Addendum 1 for RFB 950200-01

Project Name: MPCF Water Main Replacement

| PROJECT: | Hot and Cold Water Main Replacement | PROJECT NUMBER: 25-182 |
| | | DATE: February 19, 2026 |

11 TUNNEL NORTH SECTION PIPE FLOOR SUPPORT DETAIL
No Scale

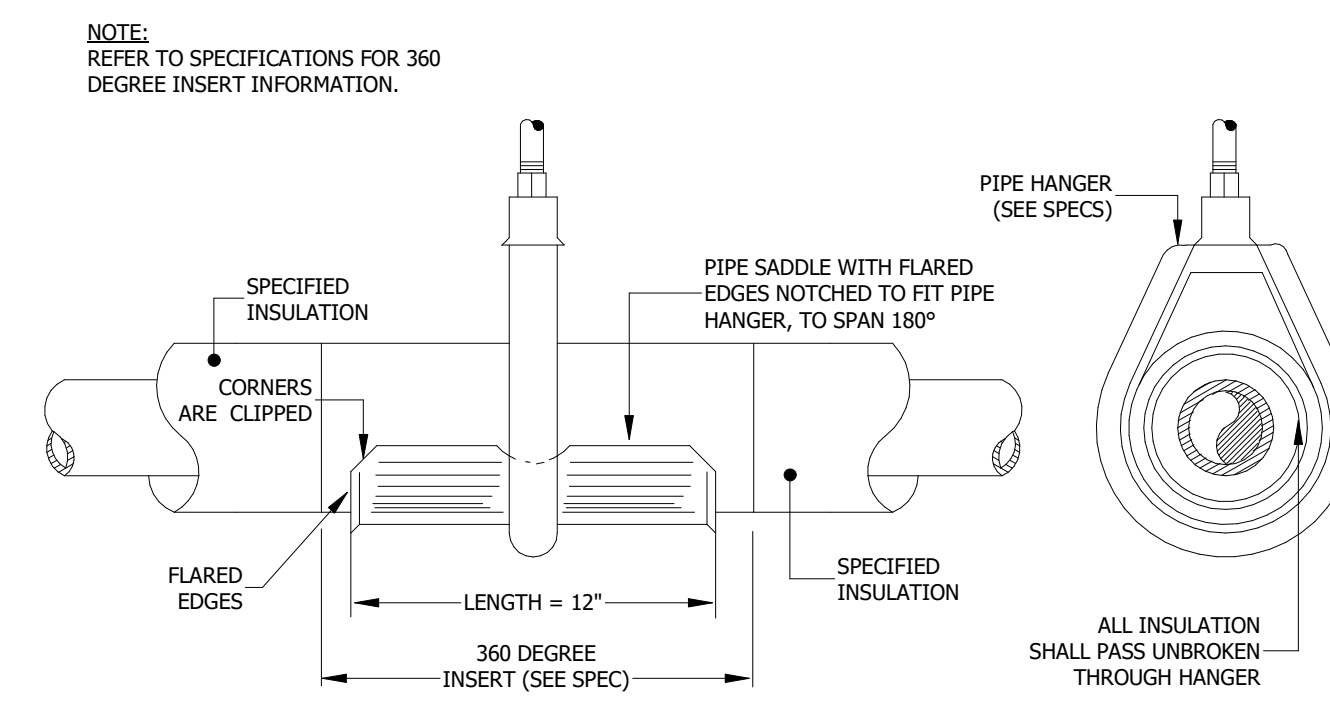
- VIEW 1 - TUNNEL NORTH SECTION PIPE FLOOR SUPPORT DETAIL
 1. **ADD** detail in its entirety. Refer to supplemental drawings for additional details.
